Technical Service Bulletin

91 SOS warning displayed in instrument cluster, DTCs B105313 and B153313 stored in the data bus diagnostic interface

91 20 60 2054812/3 April 22, 2020. Supersedes Technical Service Bulletin Group 91 number 19-58 dated May 13, 2019 for reasons listed below.

Model(s)	Year	VIN Range	Vehicle-Specific Equipment
A4, A5	2018 - 2019	All	With connected gateway and eCall

Figure 2. GSM antenna location reference at the data bus on board diagnostic interface, J533 (address word 0019).

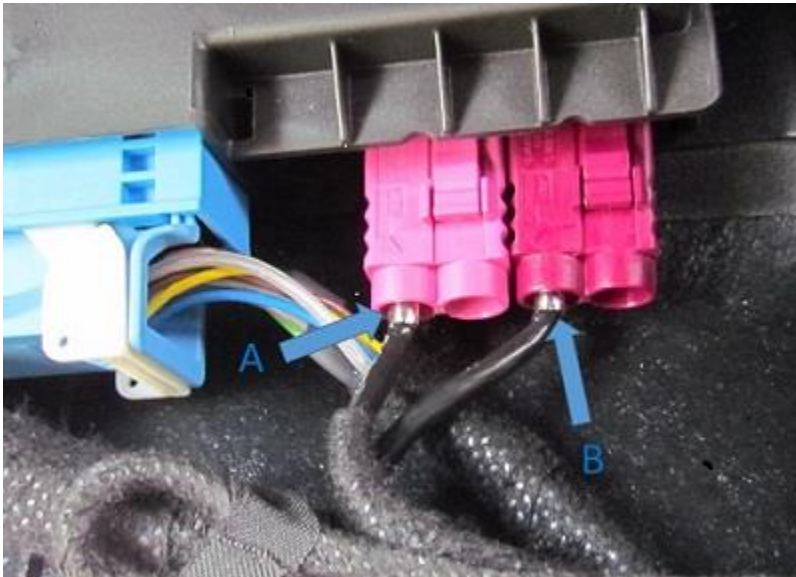
DTC Reference Table			
DTC	Measured Value Diagnostic Address 0019	Cable Position (Figure 2)	Vehicle PR-Codes
B105313 GSM antenna Open circuit	Antenna for telephone status 0x24E2	A	IW3 IW5 + 4GR IW5 + 4GY
B153313 GSM antenna 2 Open circuit	Status of antenna 2 for phone 0x1836	B	IW3 IW5

1. If DTC B105313 or B153313 are found in the data bus on board diagnostic interface, J533 (address word 0019), then replace the coaxial wire from the applicable emergency call module antenna to the data bus on board diagnostic interface, J533 (address word 0019).
2. Utilize the VAS 6720 to build a single coaxial wire from the emergency call module to the data bus on board diagnostic interface, J533 (address word 0019).
 - **Do not** split the new wire at the TIM connection between T2dkx and T2dk.
 - Route the new wire along with the existing harness.
 - Ensure that there are no sharp bends.
 - Ensure there is no tension on the new contacts.
 - The cable should be 8.7ft (2.65m) in length.
 - Transfer the plastic connectors onto new cable.
